HORSHAM DISTRICT COUNCIL CONSULTATION

TO:	Horsham District Council – Planning Dept
LOCATION:	Land To The West of Shoreham Road Small Dole West Sussex
DESCRIPTION:	Outline planning application for up to 45 dwellings (including affordable homes) with all matters reserved apart from access.
REFERENCE:	DC/25/1019
RECOMMENDATION:	More Information / Modification

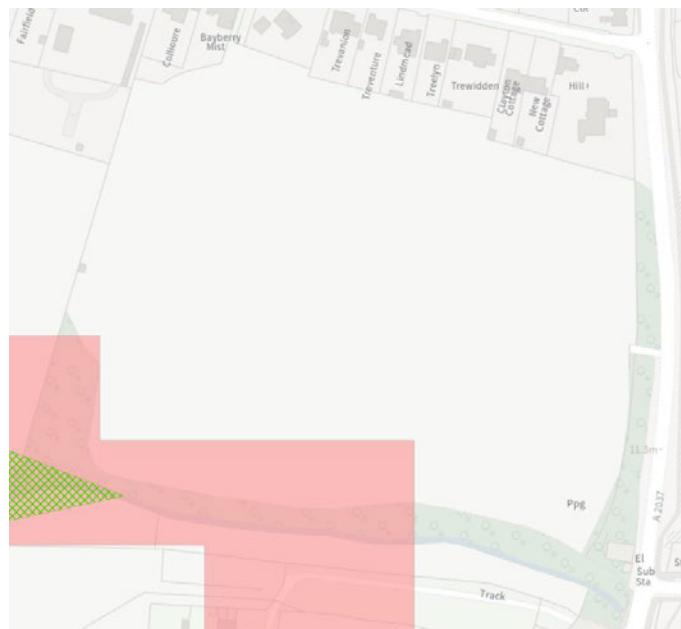
All habitats within the metric have been inputted as having a low strategic significance (area/compensation not in local strategy/no local strategy). However, please note that the south of the site comprising the priority woodland and watercourse fall within a very high potential site of the Wilder Horsham District Nature Recovery Network, and therefore as per HDC guidance, all habitats with a biodiversity value greater than zero within the metric should be assigned as having a medium strategic significance (location ecologically desirable but not in local strategy). It is therefore requested that the strategic significance for habitats in this area is amended.

^Red and green shading above indicate areas that fall within the WHD NRN route.

[This has been amended. Concern resolved, with thanks.](#)
